Abbreviated Procedures**STANDARD INSPECTION REPORT OF A LIQUID PIPELINE CARRIER**

Name of Operator: ExxonMobil Pipeline Company		
OP ID No. ⁽¹⁾ 4906	Unit ID No. ⁽¹⁾ 1255	
H.Q. Address:	System/Unit Name & Address: ⁽¹⁾	
ExxonMobil Pipeline Company 800 Bell Street Houston, TX 77002	ExxonMobil Pipeline Company 110 Cemetery Road Bridger, MT 59014	
Co. Official: Patrick Doolan	Activity Record ID#: 123899	
Phone No.: 713-656-2227	Phone No.:	
Fax No.: 713-656-2170	Fax No.:	
Emergency Phone No.:	Emergency Phone No.:	
Persons Interviewed	Titles	Phone No.
Guy Peltier	Pipeline Safety Advisor	(713) 656-3504
Larry (Doc) Hawthorne	Training Advisor	(903) 879-0313
Jeb Montgomery	Area Superintendent	(406) 657-5400
Steve Everett	Technician Leader	(406) 670-7520
James Althoff	Senior Technician	(406) 671-1108
PHMSA Representative(s) ⁽¹⁾ Michael Petronis Inspection Date(s) ⁽¹⁾ July 27 - July 30, 2009		
Company System Maps (copies for Region Files): No		
Unit Description:		
The Silvertip Pipeline delivers crude oil from the Silvertip Station (Elk Basin) in extreme southern Montana east of Belfry to the ExxonMobil Refinery in Billings, MT. The pipeline is able to receive crude oil from Kinder Morgan's Ed

Span – Station 2211+26

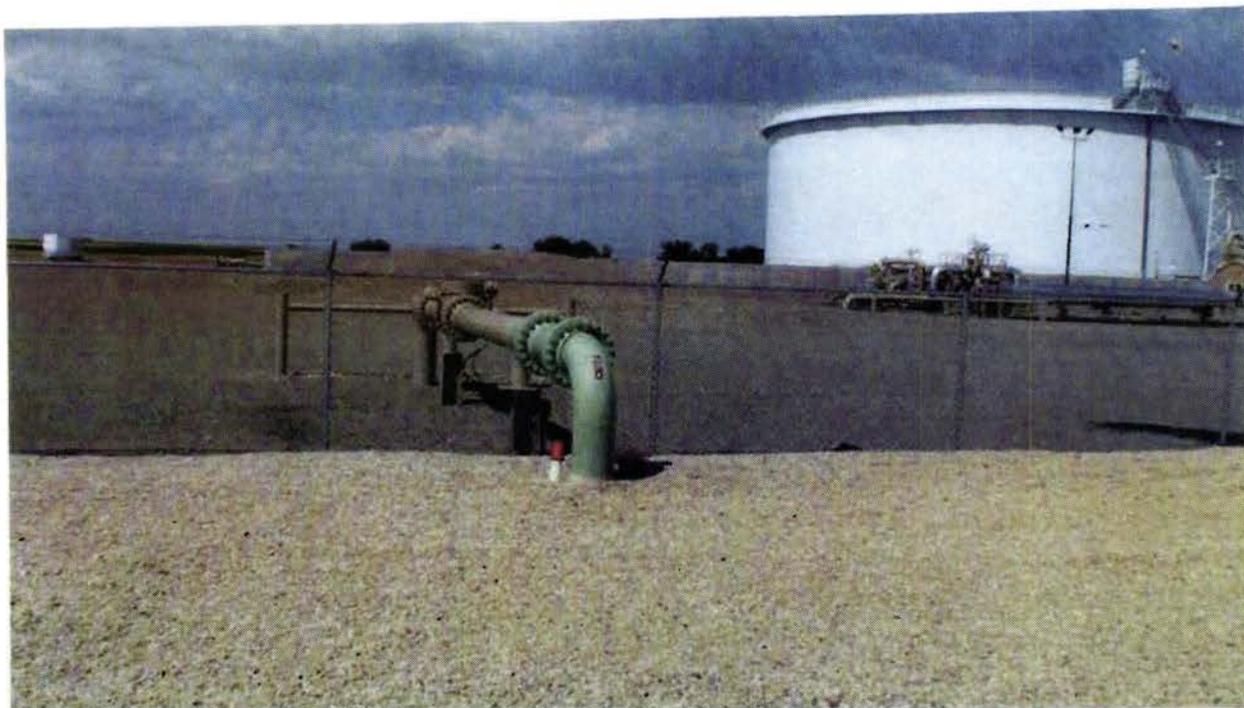
2211+26 – 10-15 ft span in flow, debris accumulated against pipeline, stump against pipeline – Goldie road /irrigation return ditch -
-1.169 mV p/s potential

Span north of Laurel (station 753+91?) – non coated exposed pipe in the foreground

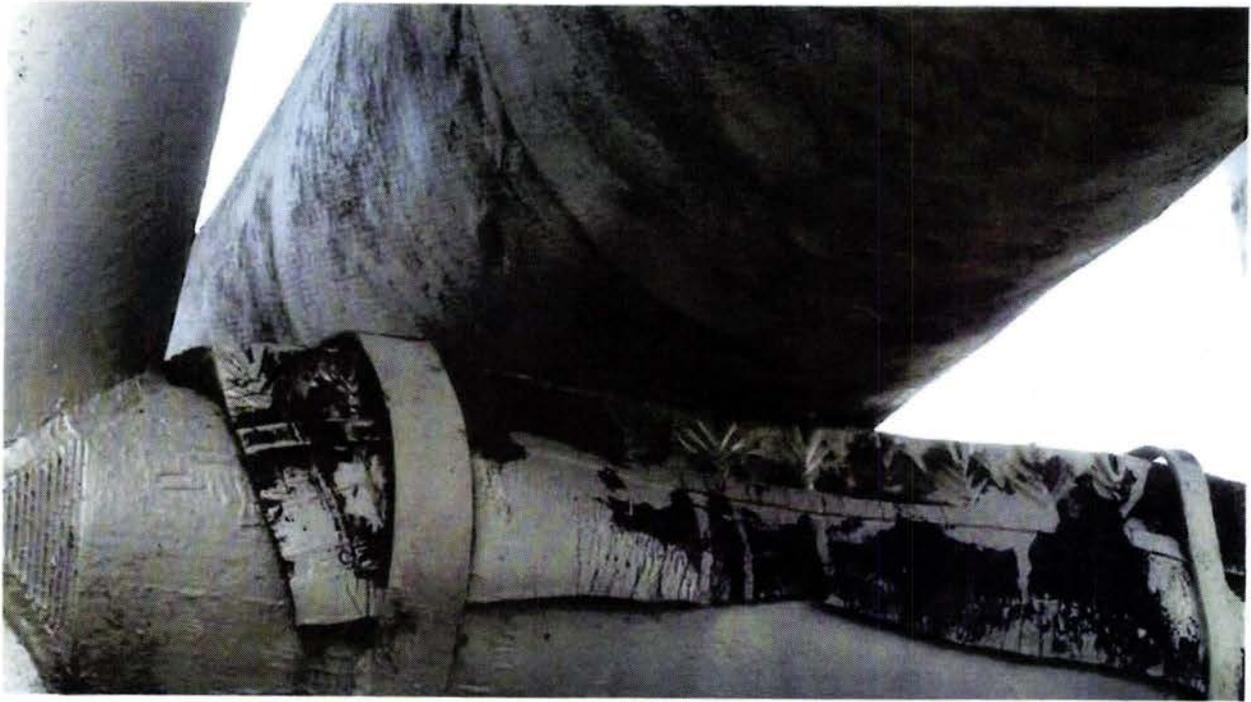
PART 195 - FIELD REVIEW		S	U	N/A	N/C
.430	Fire Fighting Equipment	X			
.432	Breakout Tanks – there are 5 tanks located at the beginning of the line at the Silvertip Station which receive crude oil from Marathon. ExxonMobil claims these are not breakout tanks due to the change of ownership of the crude oil.			X	
.434	Signs - Pumping Stations - Breakout Tanks	X			
.436	Security - Pumping Stations - Breakout Tanks	X			
.438	No Smoking Signs	X			
.501-.509	Operator Qualification - Use PHMSA Form 15 Operator Qualification Field Inspection Protocol Form	X			
.571	Cathodic Protection (test station readings, other locations to ensure adequate CP levels)	X			
.573	Rectifiers, Reverse Current Switches, Diodes, Interference Bonds	X			
.575	Electrical Isolation; shorted casings	X			
.583	Atmospheric corrosion - Exposed pipeline components (splash zones, water spans, soil/air interface, under thermal insulation, disbanded coatings, pipe supports, deck penetrations, etc.) – The pipe support on the launcher barrel at the Silvertip Station shows evidence of corrosion at the pipe/pipe support interface. A portion of the span over a canal east of Laurel is not coated to protect the pipe from atmospheric corrosion.		X

Valve 1061 Before Work

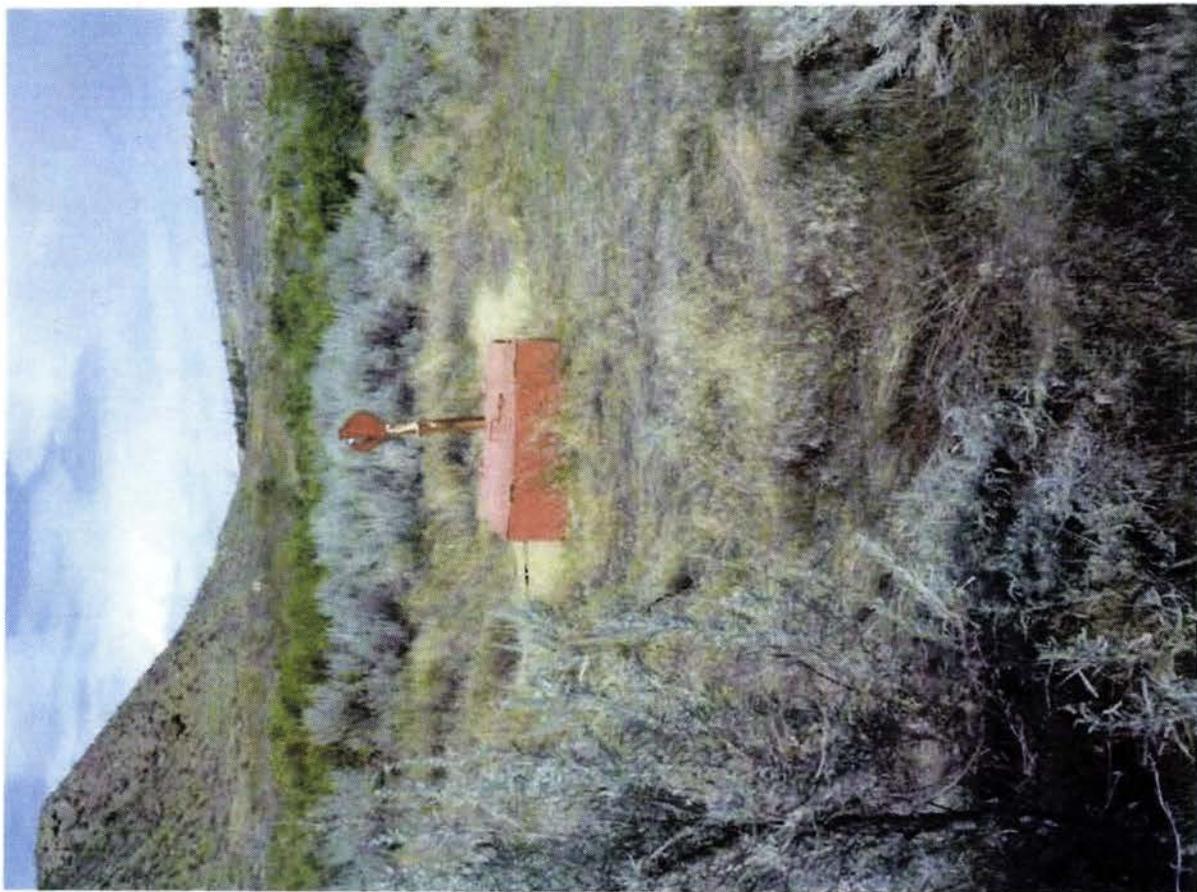
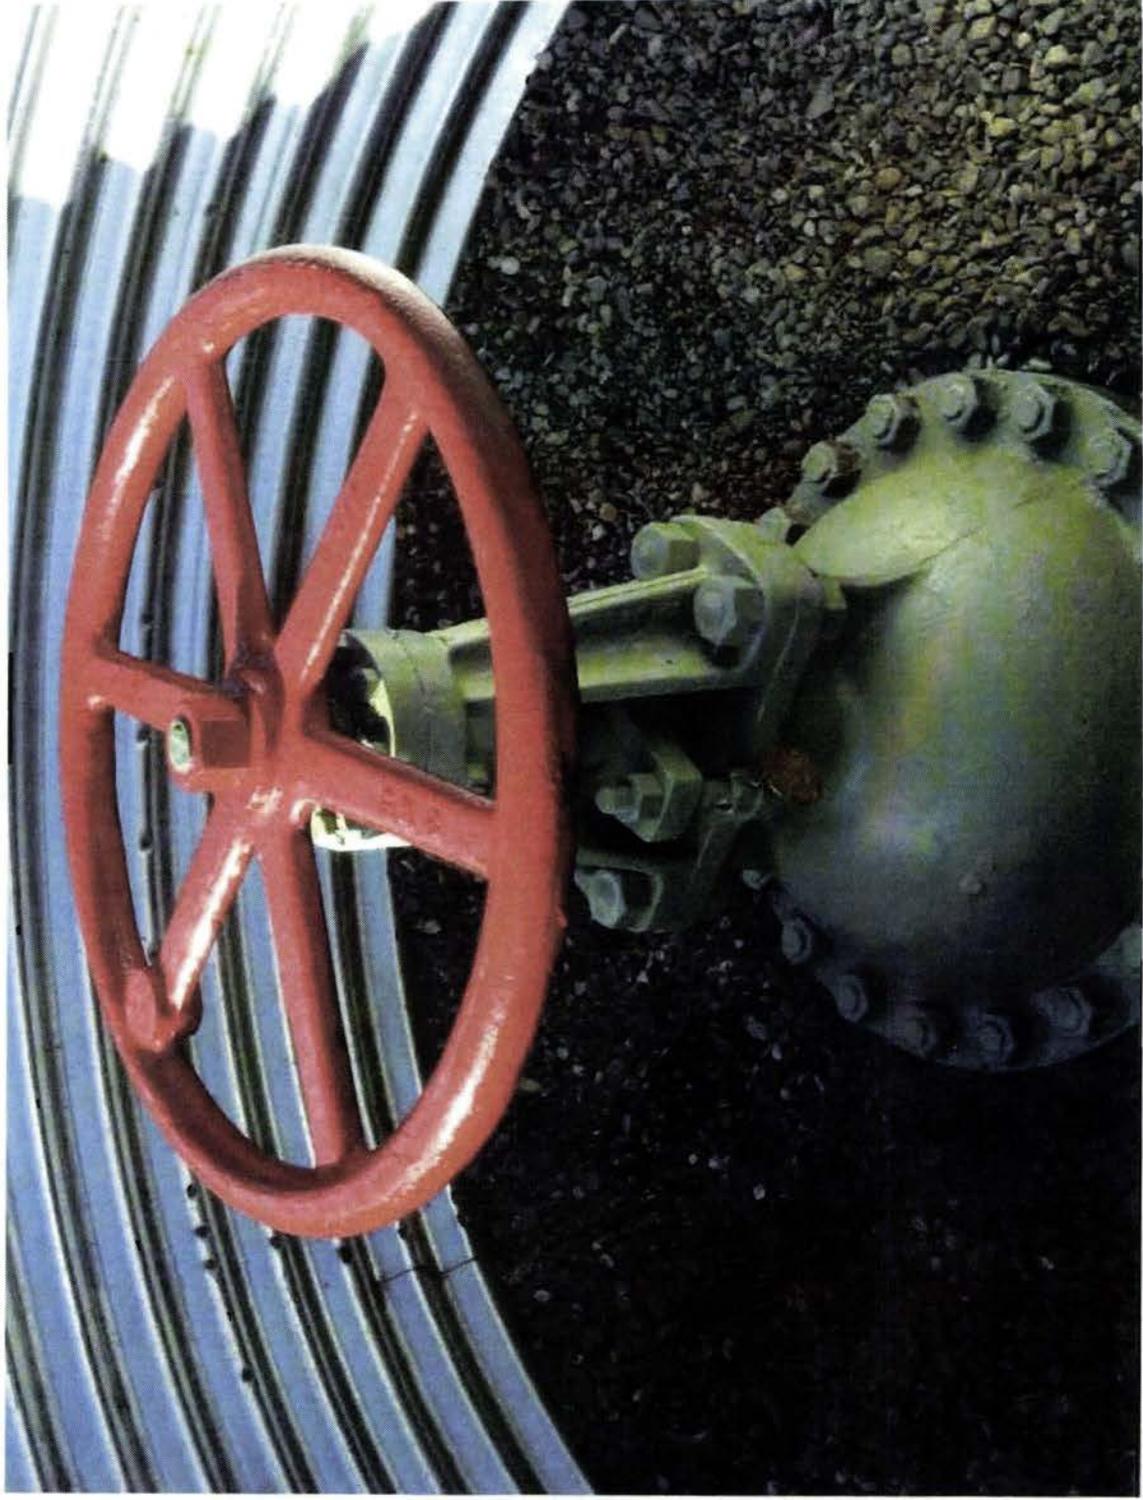
Mainline Valve 1061 (near aerial marker 50)

Valve 1061 After Work.
Completed 8-17-09
